B 22/02/22 DEVELOPMENT APPLICATION - RFI DC DC C 10/10/22 HEARING DRAFT DC DC D 13/10/22 HEARING DC DC E 03/10/22 HEARING DC DC F 22/02/23 MODPICATION DC DC					
C 10/10/22 HEARING DRAFT DC DC D 13/10/22 HEARING DC DC E 03/11/22 HEARING DC DC F 22/02/23 MODFICATION DC DC	Α	21/12/21	DEVELOPMENT APPLICATION	DC	DC
D 13/10/22 HEARING DC DC E 03/11/22 HEARING DC DC F 22/02/23 MODFICATION DC DC	В	22/02/22	DEVELOPMENT APPLICATION - RFI	DC	DC
E 03/11/22 HEARING DC DC F 22/02/23 MODFICATION DC DC	С	10/10/22	HEARING DRAFT	DC	DC
F 22/02/23 MODFICATION DC DC	D	13/10/22	HEARING	DC	DC
	Е	03/11/22	HEARING	DC	DC
G 14/08/23 MODIFICATION DC DC	F	22/02/23	MODFICATION	DC	DC
	G	14/08/23	MODIFICATION	DC	DC

129 DOVER ROAD, ROSE BAY, NSW 2029 PROPOSED RESIDENTIAL DWELLING

DRAWING STATUS MODIFICATION JOB N° 21195
REVISION N° G
DATE 22/02/:
SCALE As indic
DRAWN BY SE 22/02/23 As indicated @ A1 SE CHECKED BY DC

VIEW FROM 131 DOVER ROAD
PREVIOUSLY APPROVED DESIGN
LEVEL 01 REAR OPEN BLADE WALLS

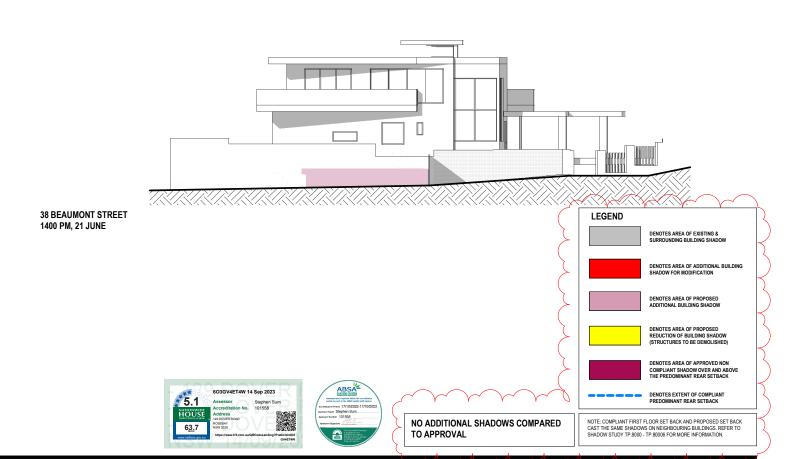
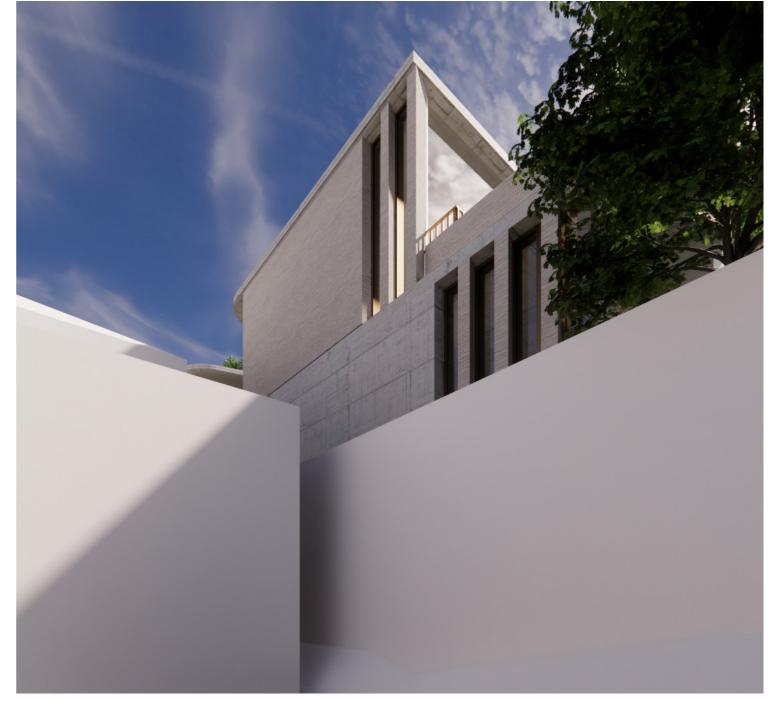
MODIFIED DESIGN

LEVEL 01 REAR ENCLOSED BLADE WALLS WITH GLAZING

VIEW FROM 127 DOVER ROAD
PREVIOUSLY APPROVED DESIGN
LEVEL 01 REAR OPEN BLADE WALLS

MODIFIED DESIGN

LEVEL 01 REAR ENCLOSED BLADE WALLS WITH GLAZING
